Department of Energy
Washington, D.C. 20545
Docket No. 50-537
HQ:S:82:155

ADDITIONAL INFORMATION REGARDING PRELIMINARY SAFETY ANALYSIS REPORT (PSAR) CHAPTER 4 "REACTOR" ON THE CLINCH RIVER BREEDER REACTOR PLANT

Reference: Letter HQ:S:82:139, J. R. Longenecker to P. S. Check, "Reactor Design (Chapter 4) Working Meeting, November 25 and 26, 1982 - Additional Information," dated December 6, 1982

FIG. 1: VARIATION OF MAXIMUM CLADDING TEMPERATURE WITH TIME SINCE REACTOR SHUTDOWN FOR REFUELING ACCIDENT.

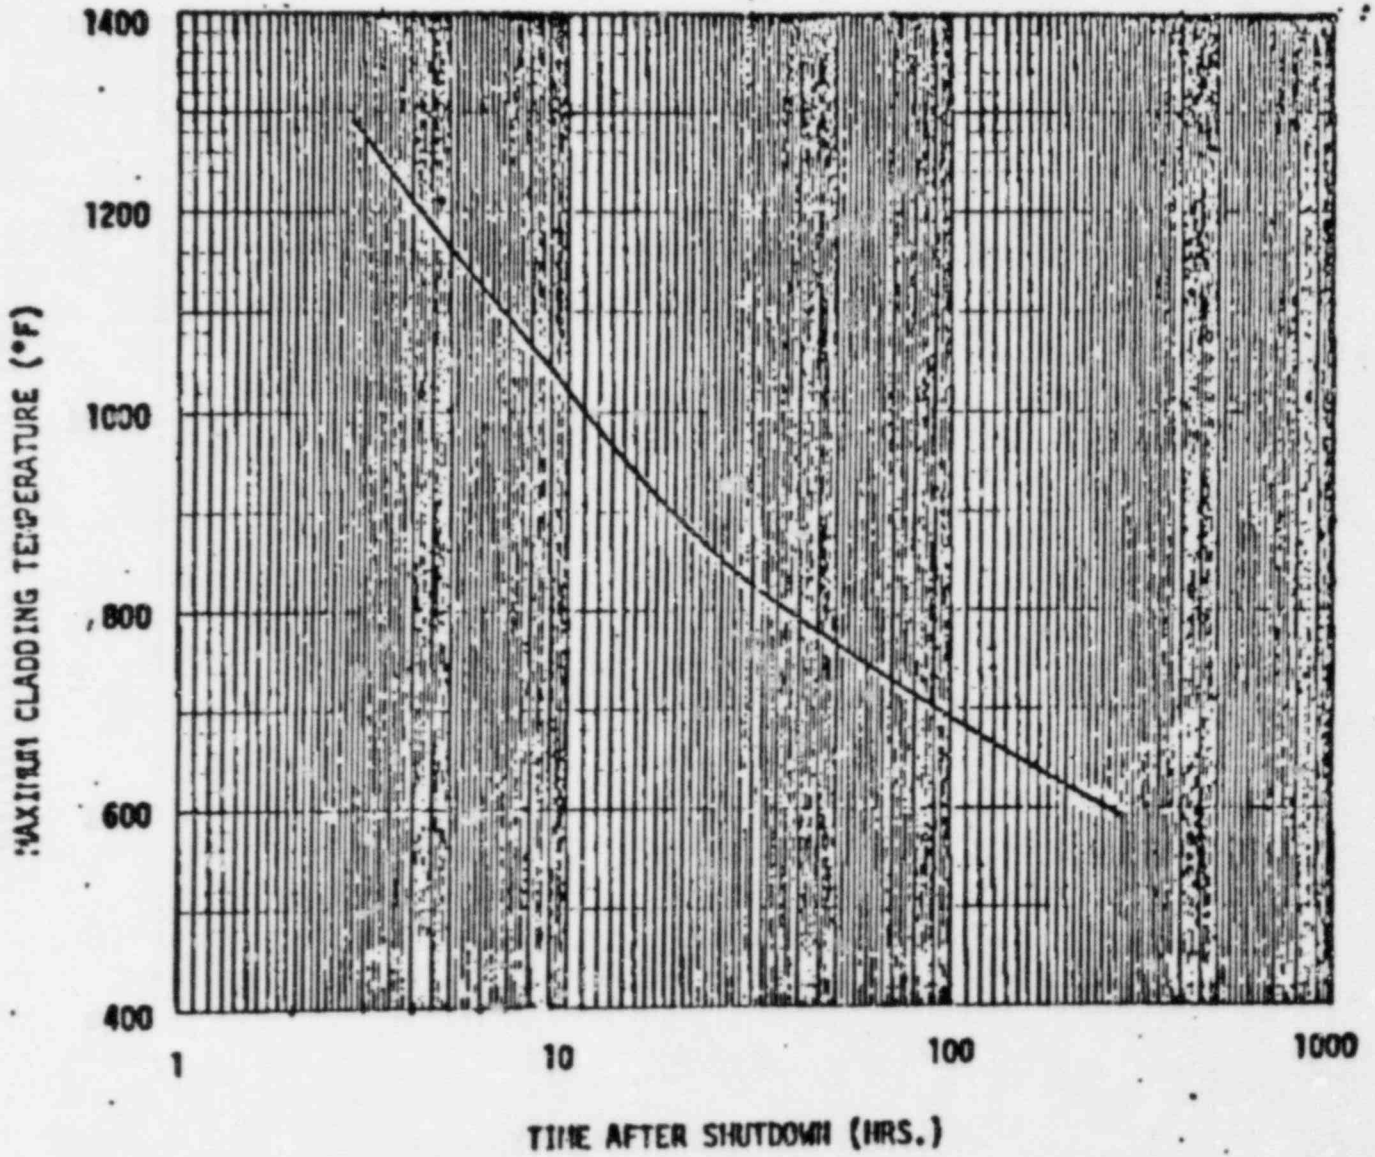
Describe design features to prevent core assembly outlet flow blockages.

The applicant will provide the NRC with the results of an analysis which demonstrates that should a total blockage of an assembly outlet nozzle occur six hours after shutdown, no significant assembly degradation will result.

An analysis was performed to determine the maximum cladding temperature due to complete blockage of a fuel assembly outlet nozzle during refueling. It was found that, even using a conservative analysis, the maximum cladding temperature for this accident (if it occurs after 6 hours from shutdown) would be less than that for operating conditions.

Figure 1 shows the maximum cladding temperature (i.e., for center pin) as a function of time from shutdown for the accident occurring. Typically, refueling would not be expected to start in less than two days from shutdown. However, earlier times are shown on the figure for parametric purposes. It can be noted that even at six hours from shutdown, the maximum temperature would be less

than 1125°F(*). The steady state, 3σ inner cladding temperature for the hot rod at operating conditions is larger than this value, and therefore, it would be expected that this accident condition would cause an insignificant increase in cladding damage.
